S E R V I C E N O T E

8751A Network Analyzer

Modification to allow the 8751A to control solid-state switch version 85046A/Bs

DATE: 15 August 1991

Figure 1. A1 CPU Board

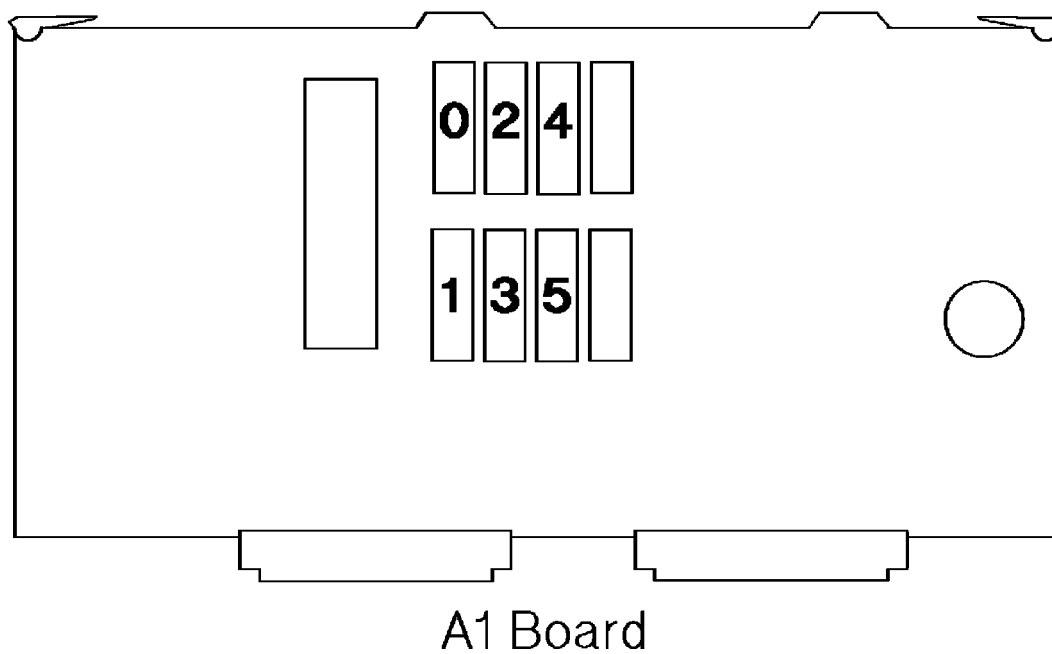
When solid-state switch version 85046A/B S-Parameter Test Sets are used with the 8751A Network Analyzer as the network measurement system, the 8751A can't control the solid-state switch version 85046A/B S-Parameter Test Set functions such as PORT selection and ATTENUATOR selection.

1. Remove the top cover and shield plate.
2. Remove the A1 board.
3. Remove the programmed ROMs from the A1 board.
4. Install the new ROMs into the ROM sockets as follows:

Reference Designator	Part Number	Description
0 (A1U43)	08751-85601	ROM (Rev. 3.02)
1 (A1U44)	08751-85602	ROM (Rev. 3.02)
2 (A1U45)	08751-85603	ROM (Rev. 3.02)
3 (A1U46)	08751-85604	ROM (Rev. 3.02)

Reference Designator	Part Number	Description
0 (A1U43)	08751-85311	ROM (Rev. 3.02)
1 (A1U44)	08751-85312	ROM (Rev. 3.02)
2 (A1U45)	08751-85313	ROM (Rev. 3.02)
3 (A1U46)	08751-85314	ROM (Rev. 3.02)
4 (A1U47)	08751-85315	ROM (Rev. 3.02)
5 (A1U48)	08751-85316	ROM (Rev. 3.02)

5. Reinstall the A1 board.
6. Connect the control cable between the TEST SET-I/O INTERCONNECT on the rear panel of the 8751A and the NETWORK ANALYSER-I/O INTERCONNECT on the rear panel of the 85046A/B.
7. Turn the 8751A ON. Confirm that the “POWER ON TEST FAILED” message is NOT displayed.
8. Confirm that the PORT 1 LED is ON, and PORT 2 LED is OFF.
9. Press [MEAS], 'Refl:REV S22[A/R]'. Confirm that the PORT 1 LED is OFF, and PORT 2 LED is ON.
10. Press [SYSTEM], 'SERVICE MENU', and 'FIRMWARE REVISION'. Confirm that the firmware revision is 3.02.
11. Turn the 8751A OFF.
12. Reinstall the shield plate and the top cover.
